Access Compliance Report Public Rights-of-Way (Curb Ramps)

Main Street: PROSPECT_ST		Cross Street: FAIRHAVEN_AVE		Location:	NE
ADA ID: RPAT211022104521	Ramp Type: Type 4 - Parallel	Initial Pass/Fail: Fail	Overall Compliance: No	Severity Score:	32

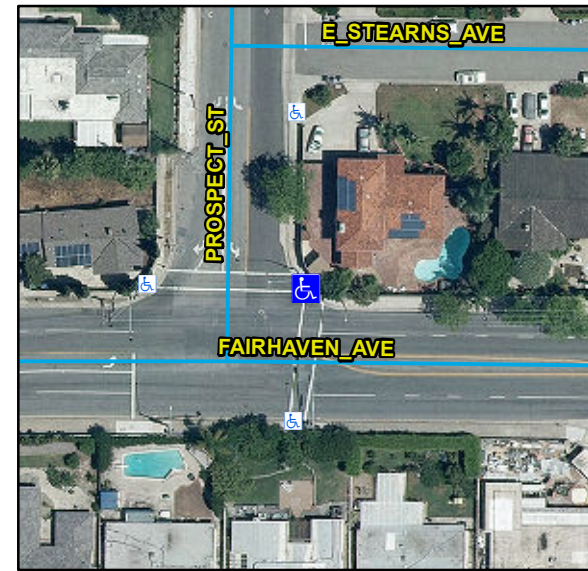
R304.3.2, R304.5.3, STD 1115

Remove & Replace Curb Ramp With Two New Directional Ramps or Equivalent.
